Process Sheet

Customer : CU-DAR001 Dart Helicopters Services	Drawing Name : TUBE ASSEMBLY	
Job Number : 35324		
Estimate Number : 11489		
P.O. Number :	Part Number : D2003027	<i>MAKE PER TEMPLATE 07.10.24</i>
This Issue : 10/23/2007 S.O. No. :	Drawing Number : UNDER REVIEW	
Prsht Rev. : NC	Project Number : N/A	
First Issue : 1 / Type : SMALL /MED FAB	Drawing Revision : B	
Previous Run : 28130	Material :	
Written By :	Due Date : 11/15/2007	Qty: 5 Um: Each
Checked & Approved By : <i>07.10.23</i>		
Comment : Est Rev A 05.12.15 New Issue AP

DESIGN <i>JE</i>	DRAWN BY <i>SP</i>	DART AEROSPACE LTD HAWKESBURY, ONTARIO, CANADA	
CHECKED <i>JE</i>	APPROVED <i>SP</i>	DRAWING NO. D2003	REV. 8 SHEET 1 OF 2
DATE 99.06.08		TITLE 206 CABIN HEATER TUBE ASSEMBLIES NTS	
A	90.04.09	NEW ISSUE	
B	99.06.08	UPDATE PER TEMPLATES; ADD P/N'S; 0.025 TUBING NOW 0.035 (TSR1049)

DESIGN <i>[Signature]</i>	DRAWN BY <i>[Signature]</i>	DART AEROSPACE LTD HAWKESBURY, ONTARIO, CANADA	
CHECKED <i>[Signature]</i>	APPROVED <i>[Signature]</i>	DRAWING NO. D2003	REV. B SHEET 2 OF 2
DATE 99.06.08	TITLE 206 CABIN HEATER TUBE ASSEMBLIES NTS

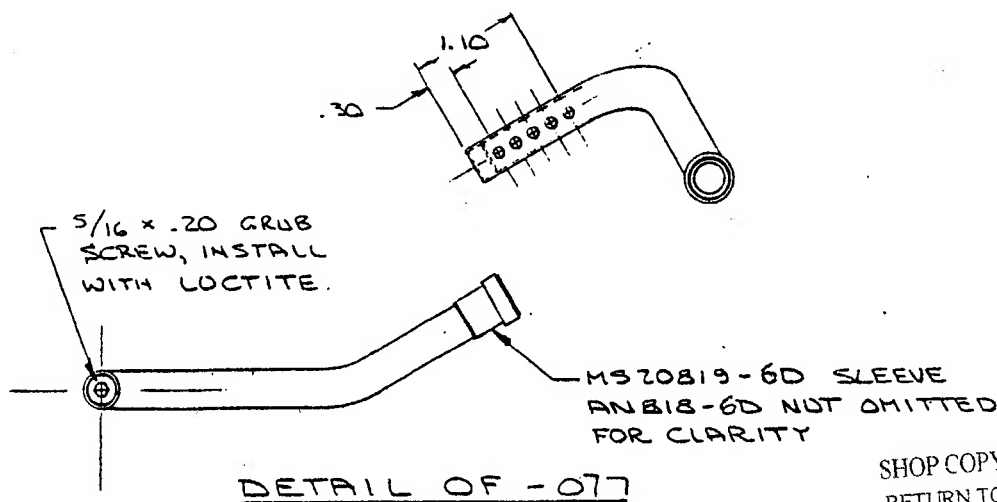
UNDER REVIEW

Some flat lengths
and wrong

07.10.24
